BWROG Paper on Application of 40% Reduction in Debris Damage Pressures to BWRs Revision 1

BWROG Position

It is the position of the BWROG that the NRC Staff's recommended 40% reduction in debris damage pressures, as described in the NRC SE on the PWR Guidance Report NEI 04-07, from those determined in the BWROG Air Jet Impact Tests (AJIT), as documented in the Utility Resolution Guide (URG), should not be applied to BWRs.

Figure 1
Marviken Stagnation Pressures

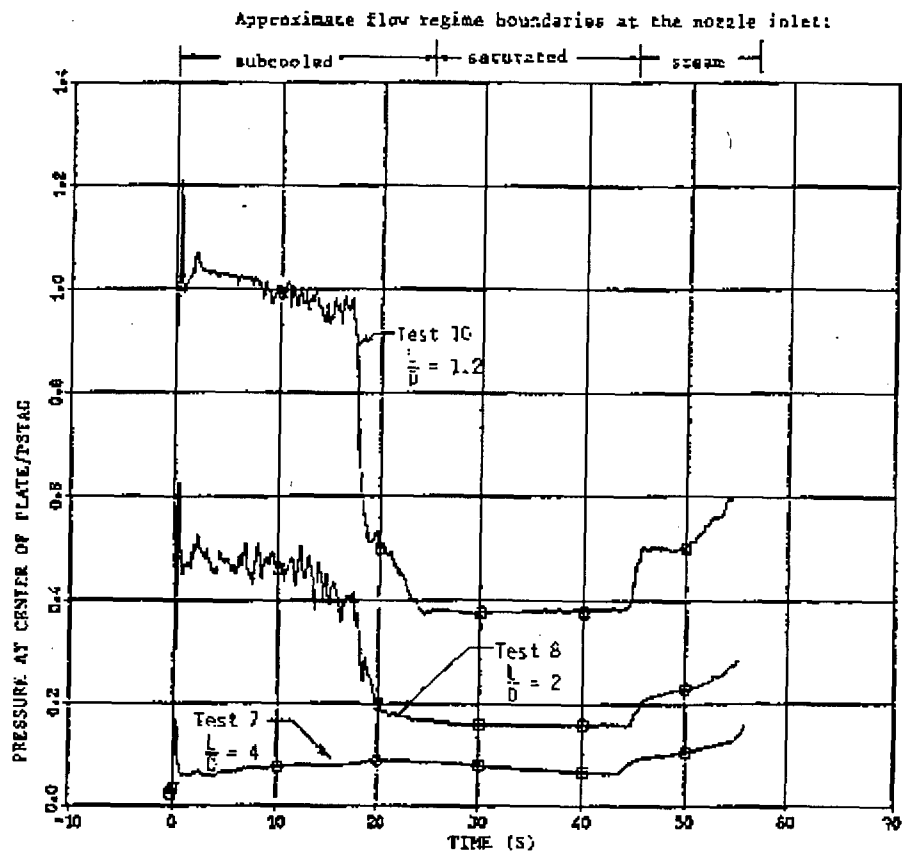
The BWROG understands the NRC's concern, given the substantially different base thermodynamic conditions that exist in PWRs relative to BWRs, and the generally accepted results from the Marviken test program that conclusively demonstrated that jet impact forces (and stagnation pressures) are at least twice as high for subcooled liquid jets than for saturated liquid jets. The Marviken tests also demonstrated that saturated vapor ("steam") jets yield slightly higher impact forces than saturated liquid jets. (See Figure 1)

In the BWROG URG it was demonstrated that the stagnation pressures of air jets are conservative relative to steam jets, which in turn are conservative relative to two-phase jets from saturated water piping.

Figure 2 AJIT Test 15-4 Post-Test Conditions

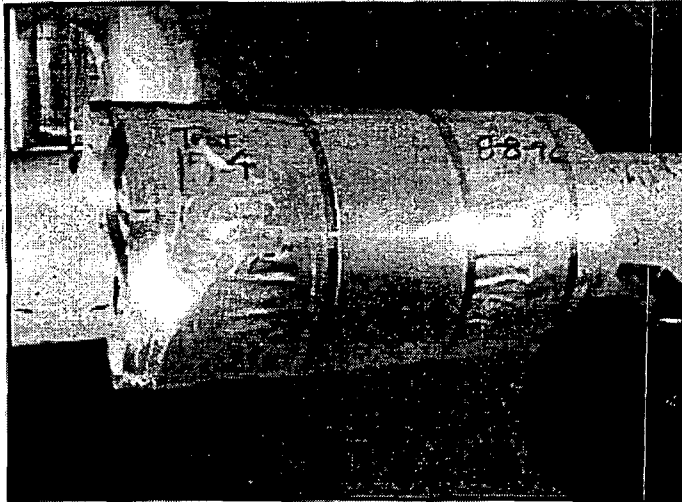
In the AJIT tests, the results showed essentially no damage for tests 15-1 through 15-3. Test 15-4 had minimal damage with more than 95% of the insulation remaining intact on the target pipe. The jacket was deformed, but remained on the target pipe. The primary damage was at one end of the 36-inch long segment. (See Figure 2) The stagnation pressure at the target surface was calculated to be approximately 160 psig. The NRC SE on the URG accepted a value of 150 psig as the debris failure pressure for this type of insulation.

Figure 3
AJIT LDFG Insulation Target Configuration

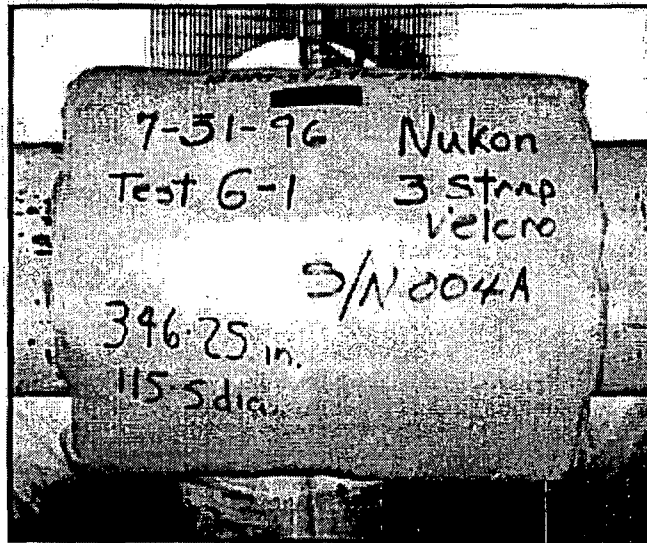
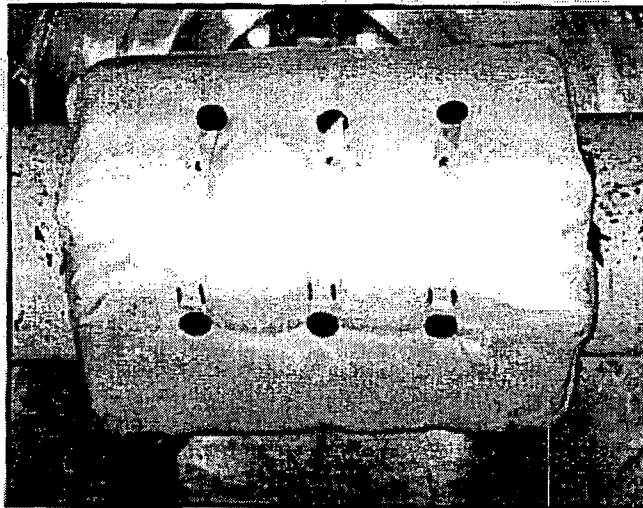
AJIT Tests 5 and 6 used unjacketed NUKON® fiberglass insulation. Table 2 provides a comparison of the tested insulation geometries. (See Figures 3 & 4)

Figure 4
Jacket/Insulation Target Comparison

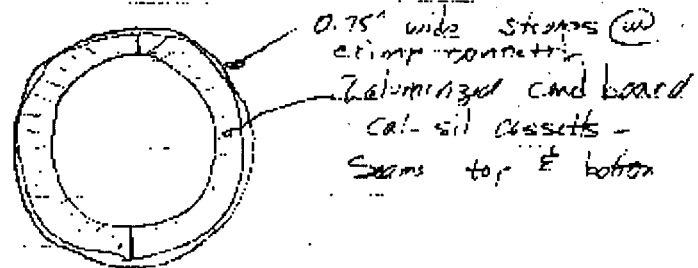
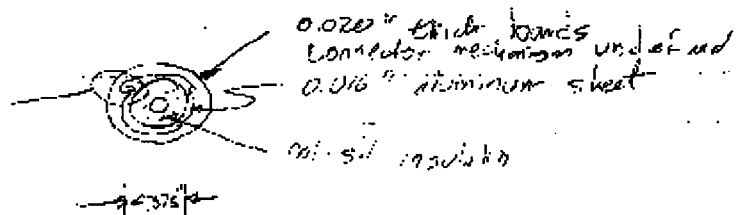
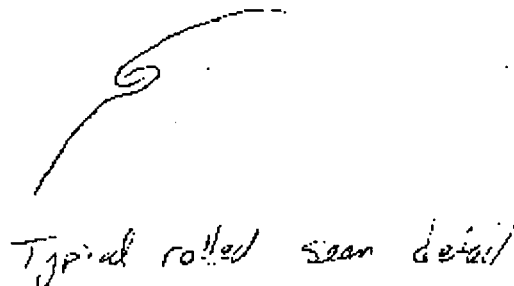
The diameter of the target assemblies is another matter that requires discussion, and is absent in Reference 2. All of the AJIT tests utilized targets that were between a factor of 4 and 5 larger than OPG tests and are more representative of a BWR plant LOCA debris source that could produce a significant quantity of debris material. Neither report discusses the relationship between target size and initial jet diameter (both tests used jets of the same initial diameter). Even more important, however is the size effect of the jacket seam and closure method geometry relative to the pipe diameter. The size of the perturbation of the flow field caused by the seam in the jacket would not scale directly with pipe diameter size (the cassettes tested by the BWROG would be expected to have a relatively constant seam size). Therefore, the flow field perturbation and the associated pressures due to a specific size seam would have a smaller effect on a larger diameter pipe than for a smaller pipe.

Finally, all the OPG tested configurations have a radial seam in addition to the longitudinal seam in the aluminum sheet jacketing. The details of the radial seam are not given in the report, but a reasonable assumption (given the sketch of page B-1 of Reference 1) is that this seam is a simple overlap with a band encircling both the central and outboard section. This seam does not occur in any of the AJIT test articles. There is insufficient discussion of the exact failure mechanism in the OPG report text, but the figures in Appendix D (specifically D-3, -4, -13, and -14) strongly suggest simple mechanical displacement of the radial seam has a major effect on the test results. Once the longitudinal seam starts to “unwrap”, the entire jacket segment simply pulls out of the “end” band, effectively opening up the insulation inside to the jet. This single effect is a likely reason for the differences in damage pressures in the OPG test compared to the AJIT results. This failure mechanism is not applicable to the BWR-prototype insulation types as tested in the AJIT. **The AJIT and OPG experiments are not in any way comparable.**
